UNITED STATES PATENT AND TRADEMARK OFFICE

APPLICATION NO.	FILING DATE	FIRST NAMED INVENTOR	ATTORNEY DOCKET NO.	CONFIRMATION NO.
09/462,994	01/14/2000	UDO SCHWALKE	P99.2666	5747

Office Action Summary	Application No. 09/462,994	Applicant(s) SCHWALKE ET AL.	
	Examiner Brook Kebede	Art Unit 2823

DETAILED ACTION

FIG. 1

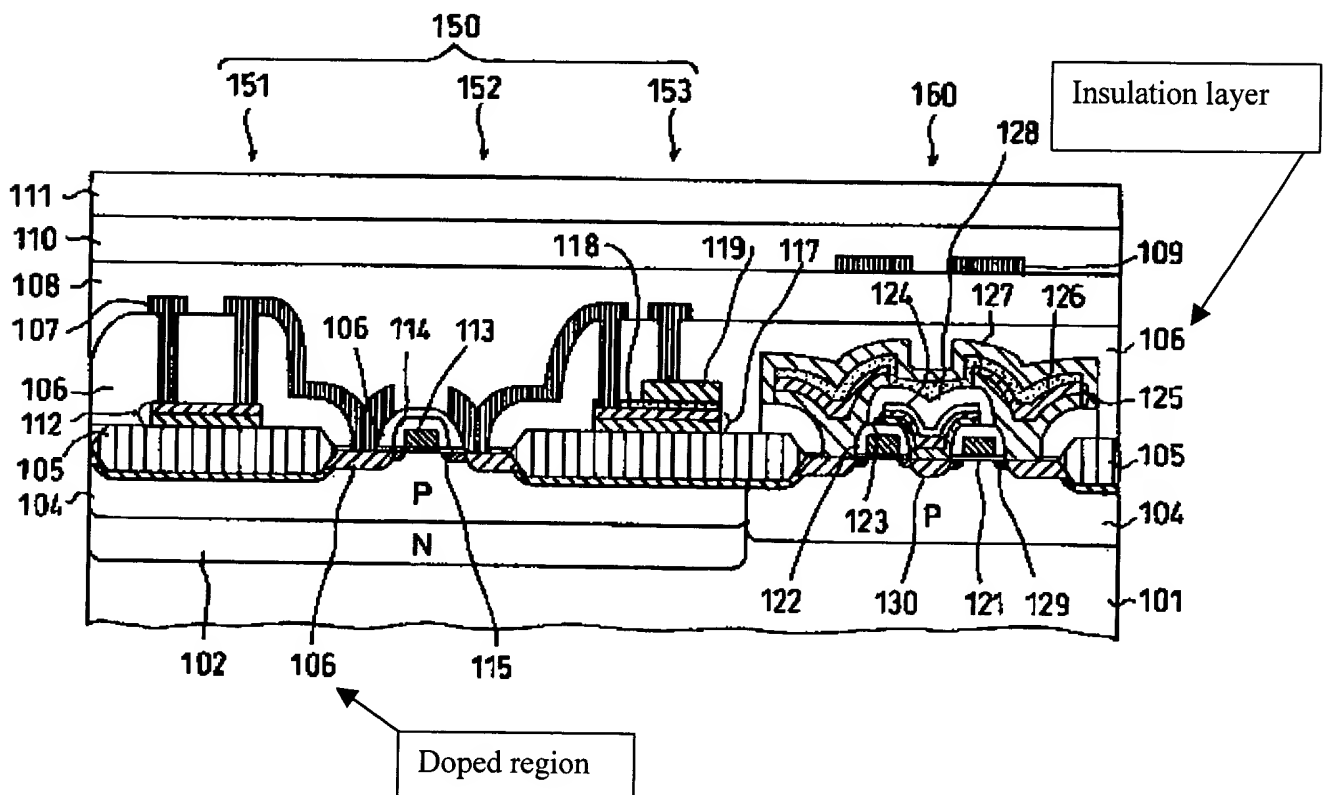
As shown above, in Fig. 1 of Shimomura et al. (US/5,736,421), both insulation layer and doped region labeled as **106**. However, the Examiner respectfully would like to point out the Applicants the two features are given same reference number and should not be doubted that the existence of

“doped region” and “insulation layer” and the two are different in terms their material content and functions.
